ADDENDUM NO. 01

July 24, 2026

**Bradford Exempted Village Schools
New Athletic Facility
760 Railroad Avenue
Bradford, OH 45308**

LPA PROJECT NO. 263401.00

11 DETAIL @ MEZZANINE RAILING

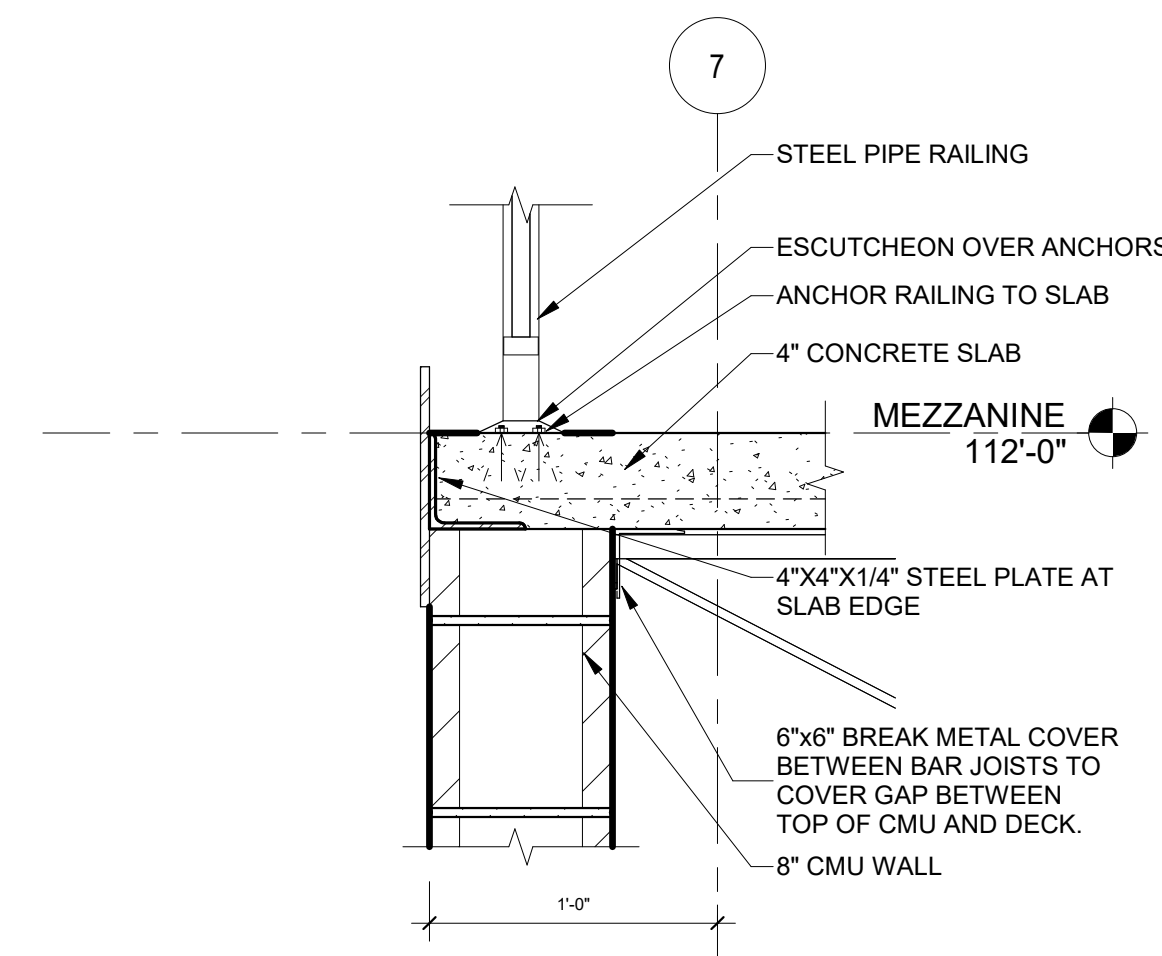
2.19.4 Revised detail 11 showing an escutcheon over the railing anchors at the floor.

12 PORCH COLUMN PIER SECTION

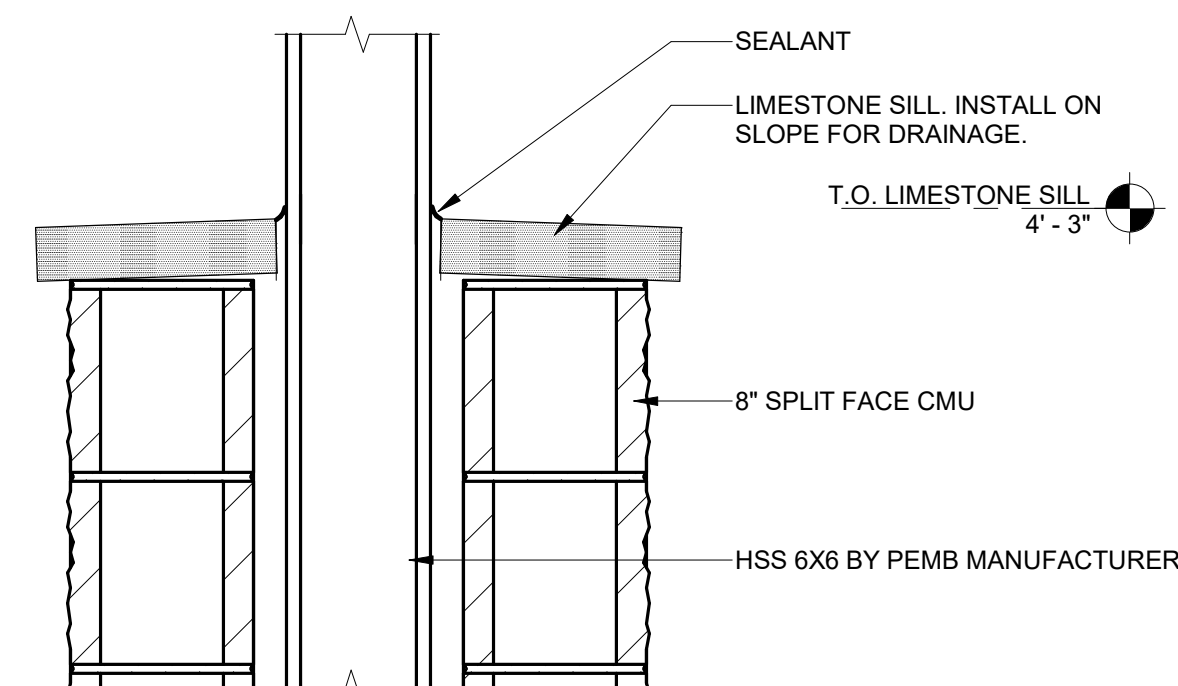
2.19.3 Revised detail 12 showing the limestone cap on the main entrance canopy column piers. The limestone caps on the canopy piers are base bid.

13 ALTERNATES G-8 AND G-9 - LIMESTONE WAINSCOT CAP

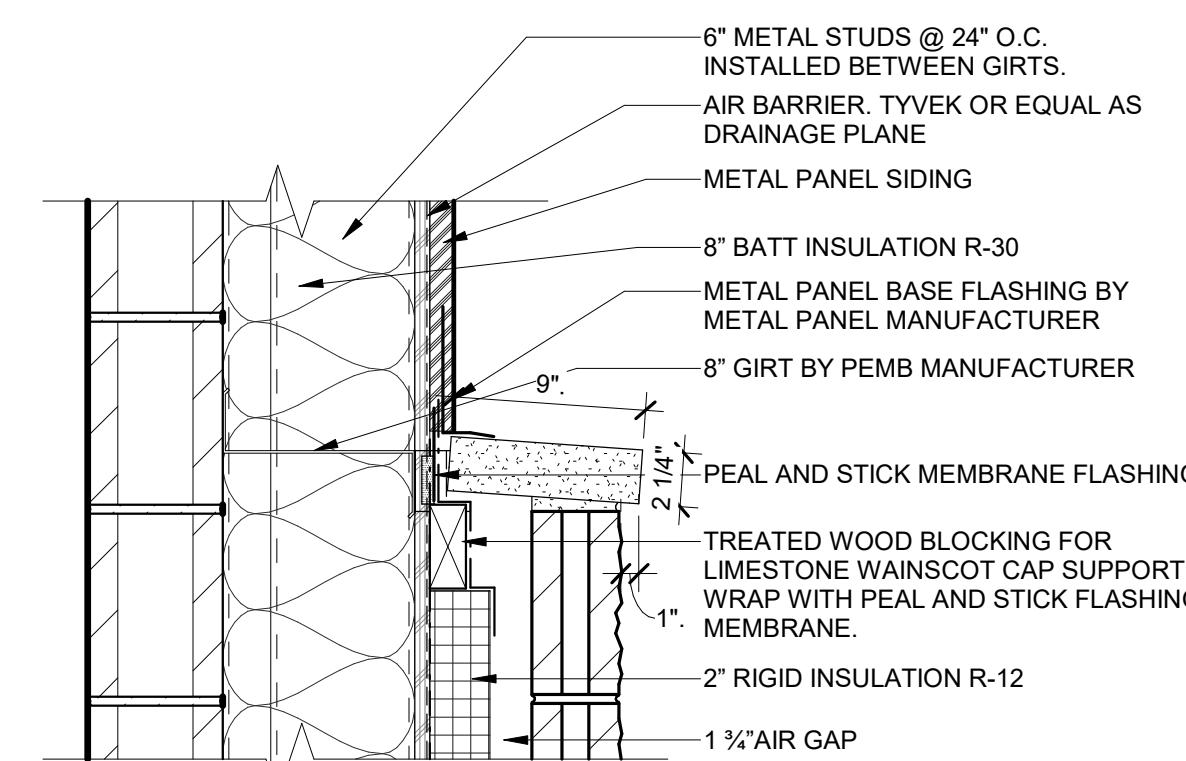
2.19.2 Added detail 13 showing the alternate limestone water table.

13 (ALTERNATE) WEIGHT ROOM STORAGE CLOSET
SCALE | 3/4" = 1'-0"

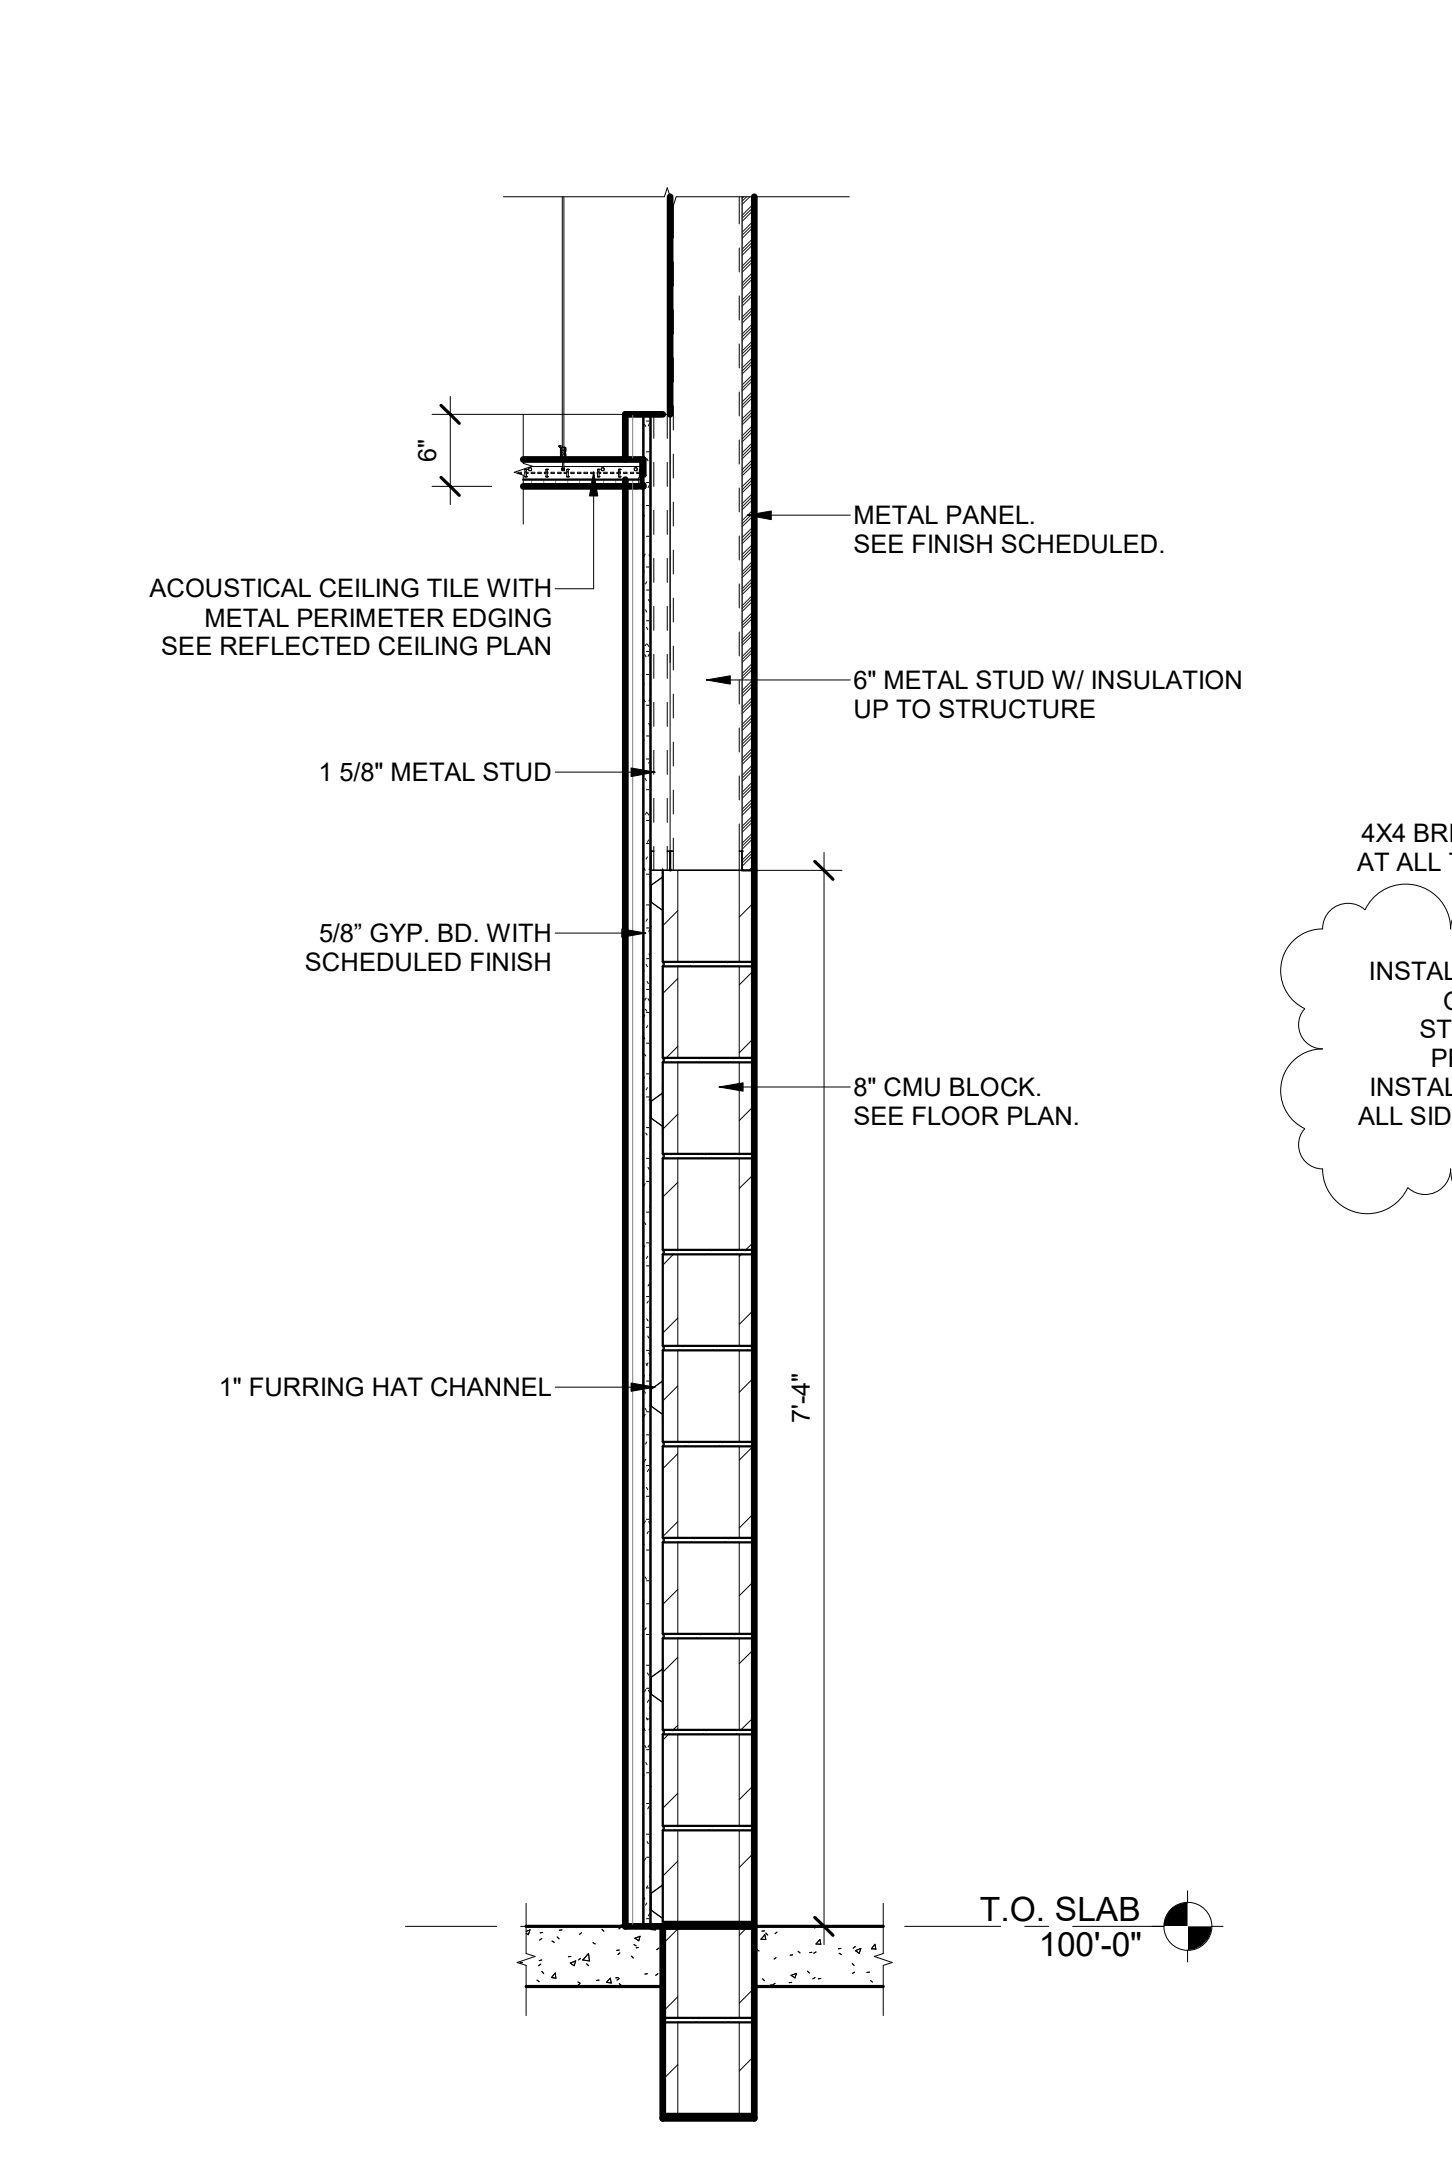
2.20.2 Revised the alternate weight room storage closet detail 13. Clarified that rubber base is to be installed both inside and outside the storage closet.

6 MEZZANINE STORAGE CLOSET
SCALE | 3/4" = 1'-0"

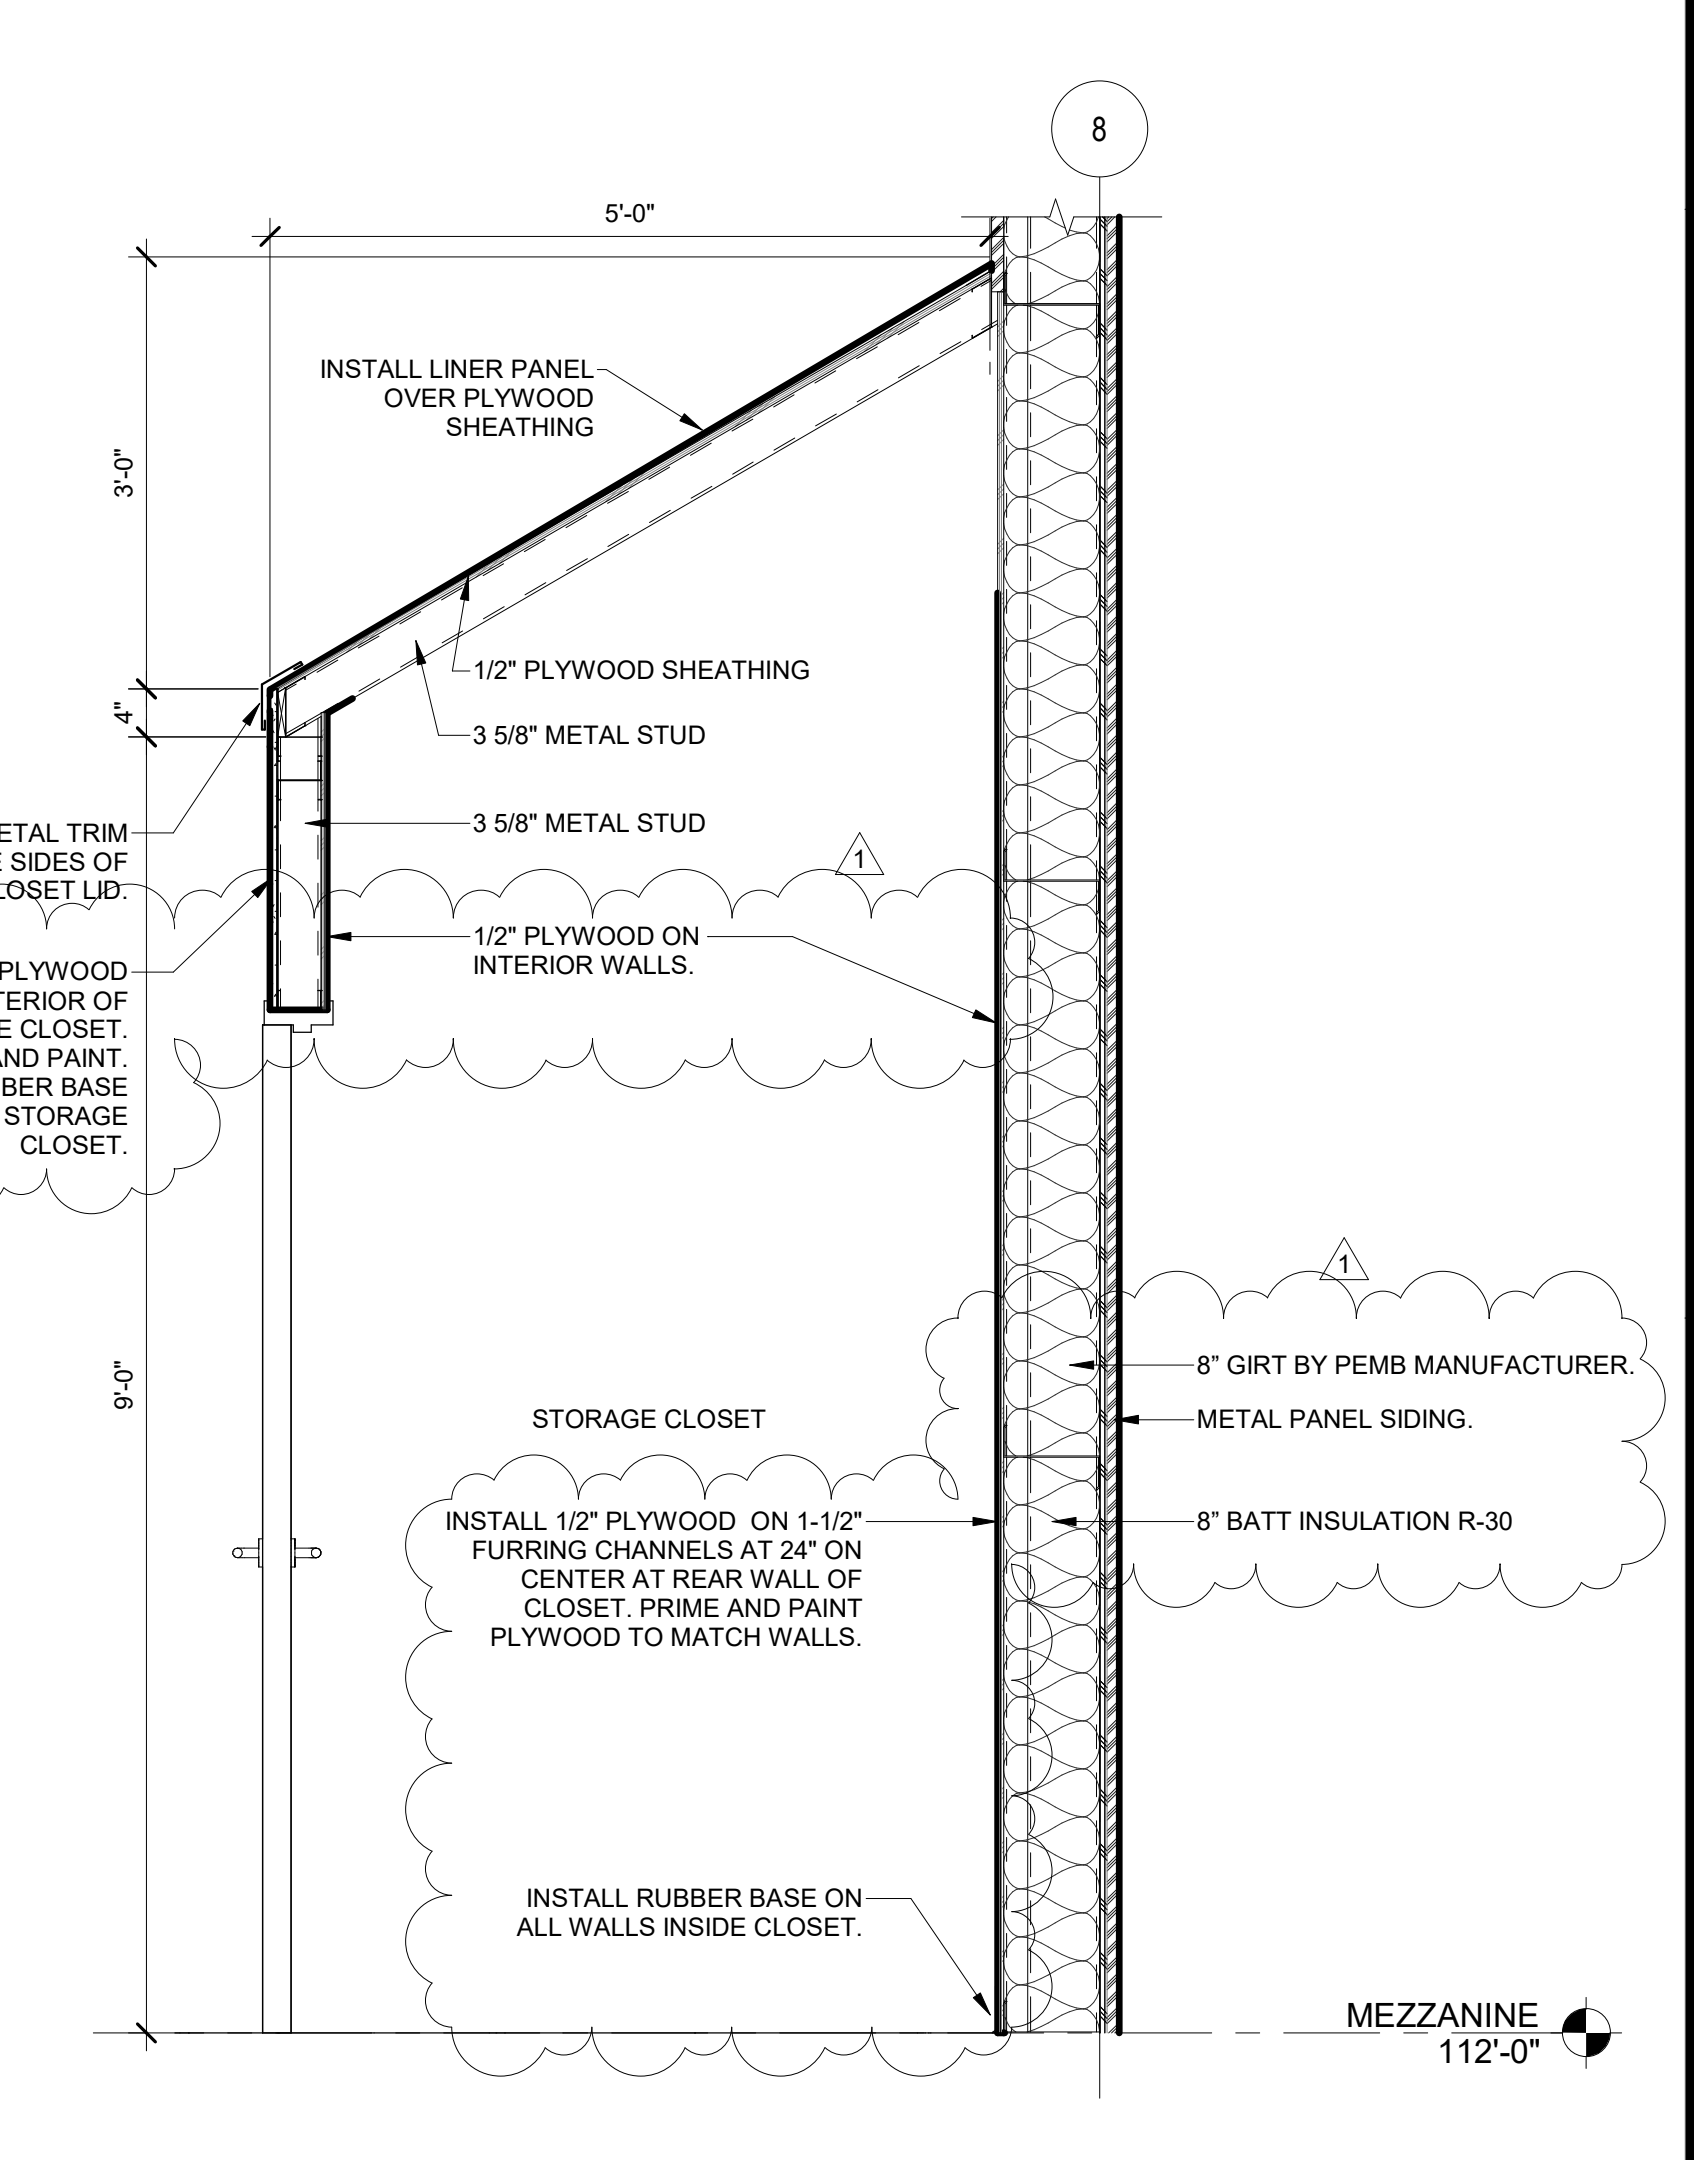
2.20.1 Revised mezzanine storage closet detail 6. Closet shall have ½" painted plywood on the exterior and interior. Install rubber base on the exterior and interior of the closet.
